This correspondence is to be used in conjunction with the photo copy mark-up of the Pinkham & Greer Plan # C-1, Rev. 2, Dated 10/14/99, that I dropped off at yours and Pinkham & Greer offices this AM.

PLANNING BOARD REPORT #61-99

TO: Kandi Talbot, Planner
FROM: Steve Bushey, DeLuca-Hoffman Associates, Inc.
RE: Scott McMullin Subdivision Application

TO: ✓ Kandi Talbot, Planner
FROM: Steve Bushey, DeLuca-Hoffman Associates, Inc.
RE: Scott McMullin Subdivision Application – Review Memo #2

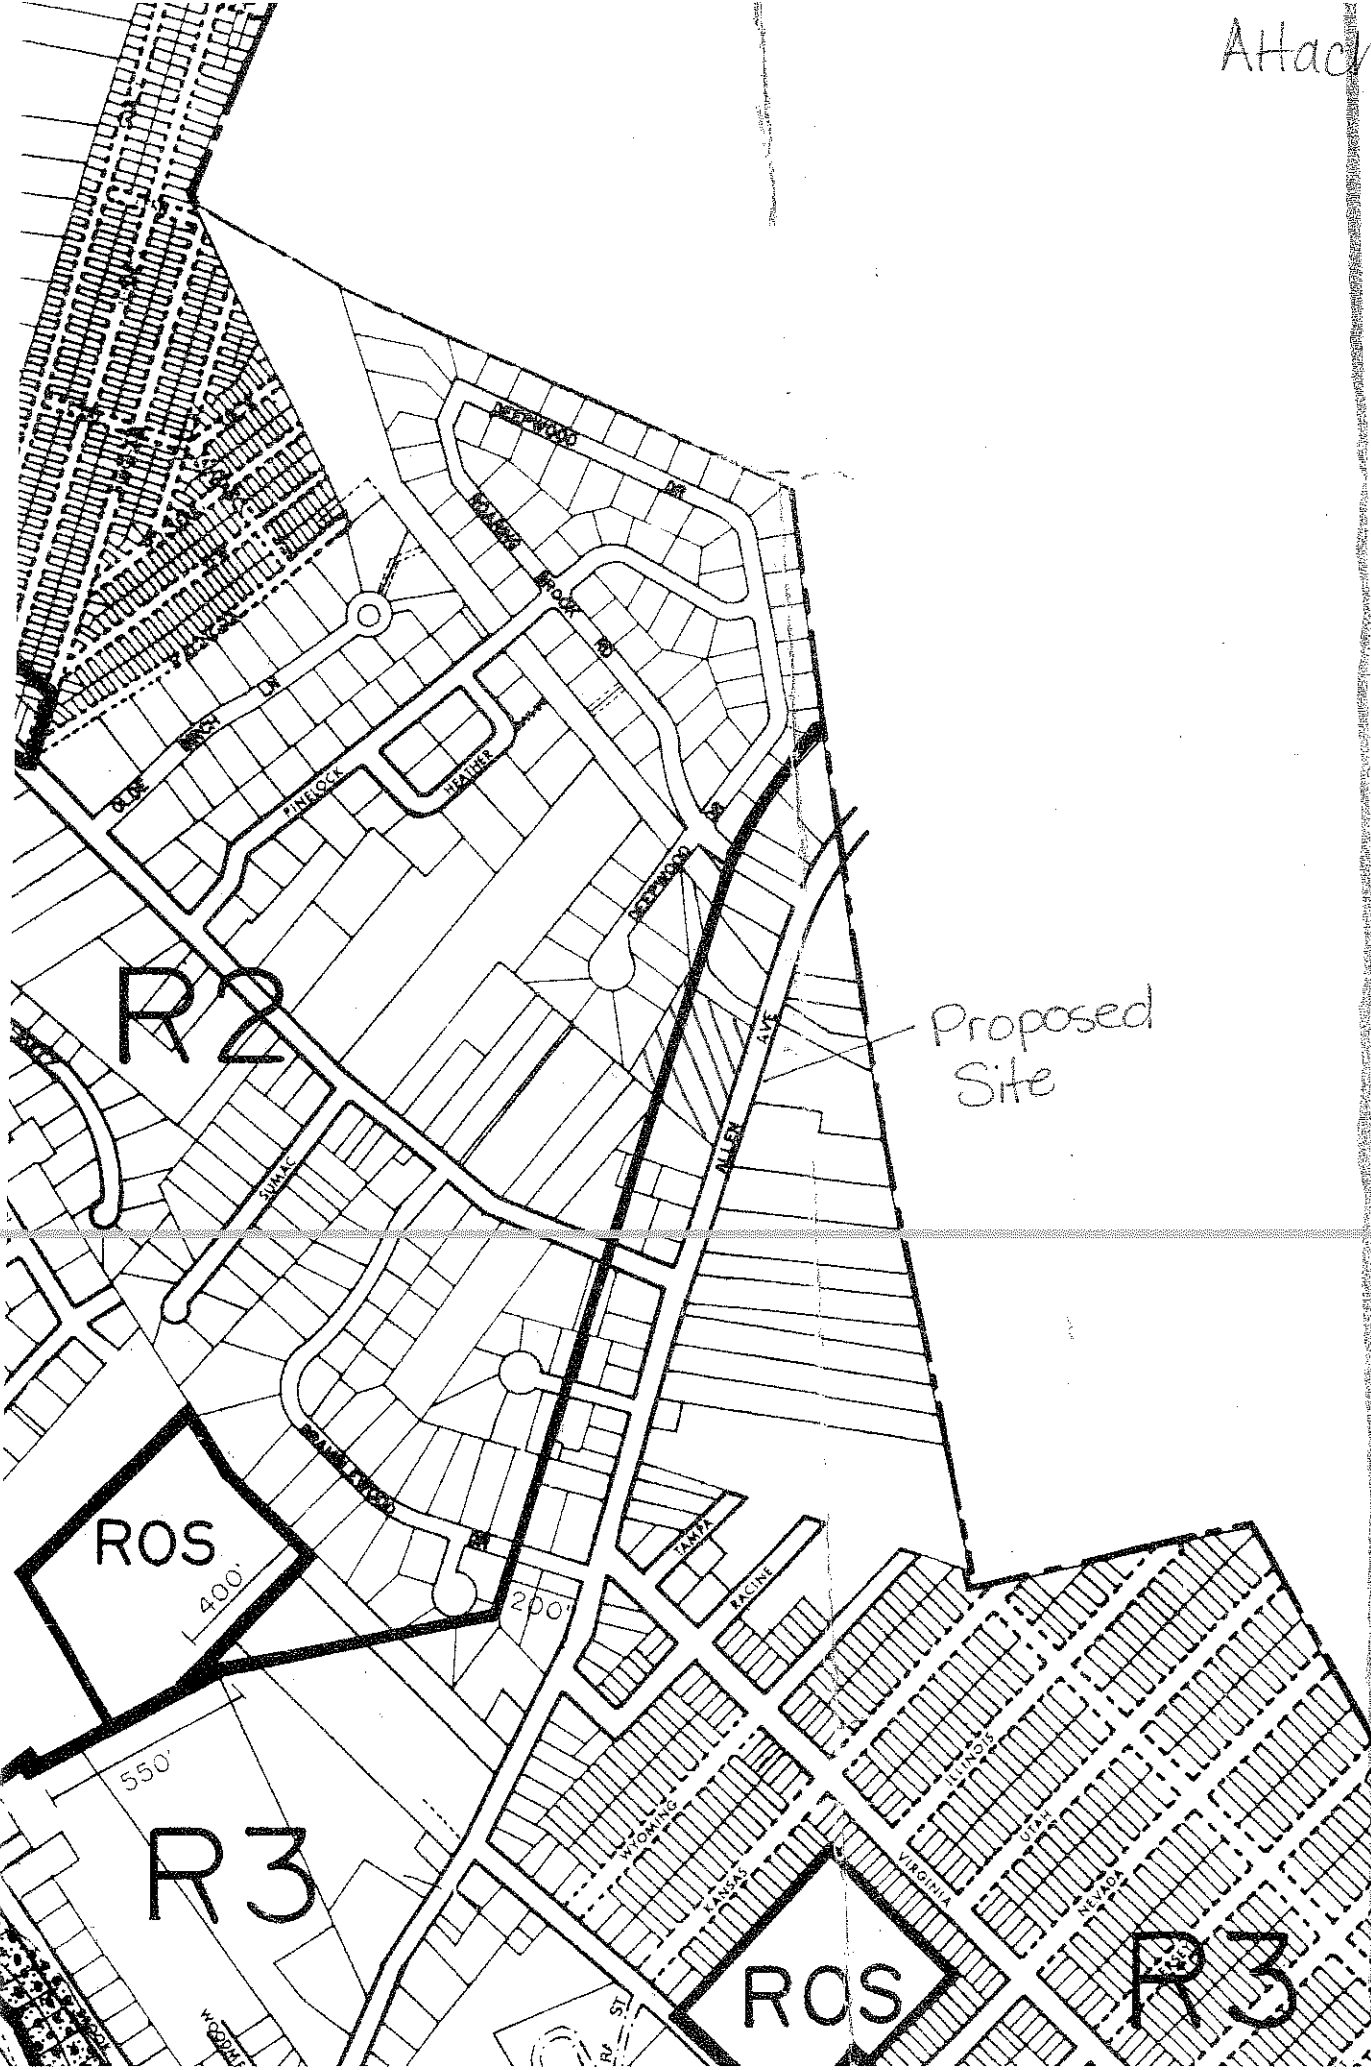
→ that utilities should be located underground including maintenance

require restriction w/ i deep filling
to be in wetland starting no
note on plan of wetland
